MC68341

ADDENDUM TO MC68341 Integrated Processor User's Manual

April 19, 1995

Figure 3-12. M68300 Write Cycle timing

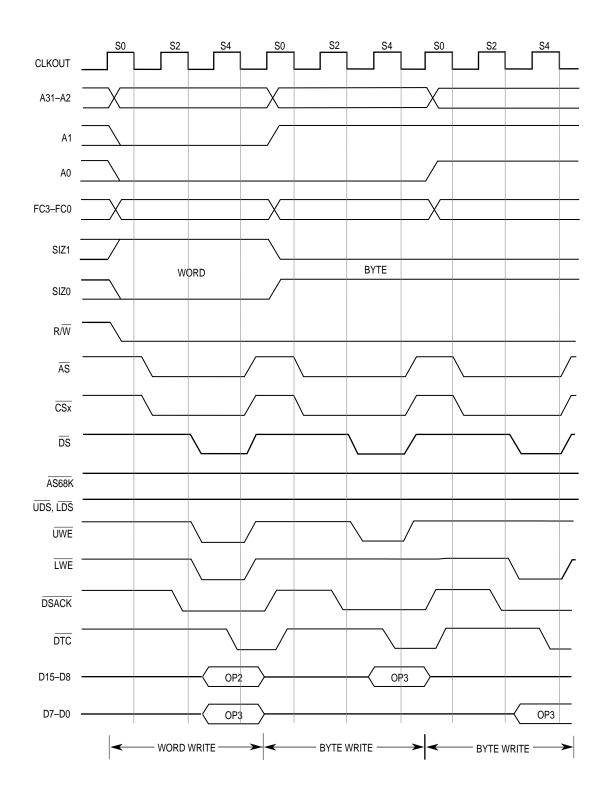
On page 3-25, the M68300 write cycle timing diagram (Figure 3-12) shows incorrect timing for \overline{DS} , \overline{UWE} , and \overline{LWE} . On page 3-28, the M68000 write cycle timing diagram (Figure 3-14) shows incorrect timing for $\overline{AS68K}$, \overline{CSx} , $\overline{UDS/LDS}$, and $\overline{UWE/LWE}$. Replace these figures with the following corrected figures.

Figure 11-14. Circuit For Interfacing 8-Bit Device to 16-Bit Memory in Single-Address DMA Mode

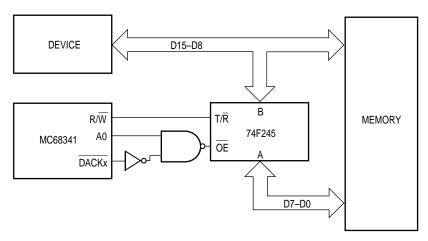
On page 11-10, the logic driving $\overline{\text{OE}}$ on the 74F245 in Figure 11-14 should be corrected as shown below. Although not detailed, the byte enables for the memory block should be controlled during reads to prevent contention between the upper and lower bytes of the data bus when D7-D0 is muxed to the upper data byte.

80. Page 9-19,

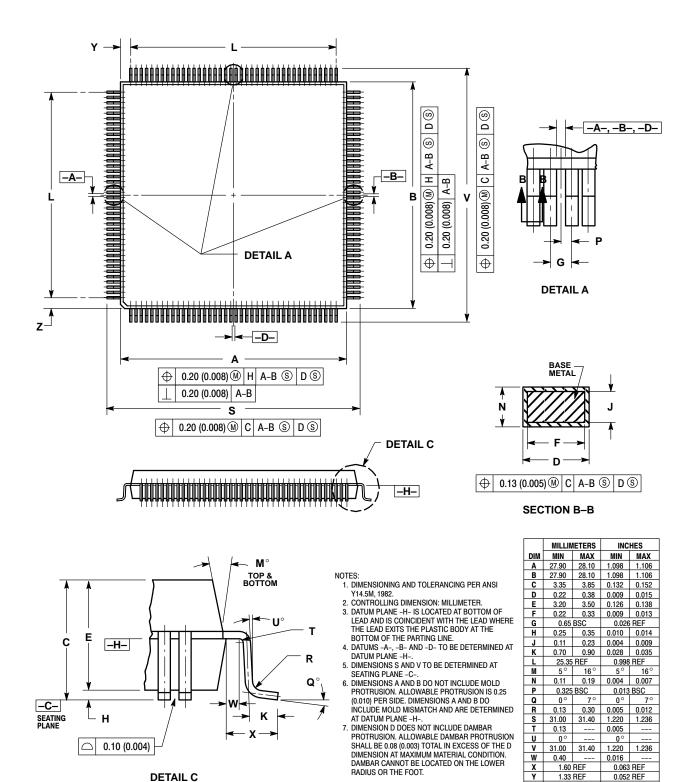
The timing diagrams reference as Figures 9-24 — 9-27 should be changes to 12-22-12-25.
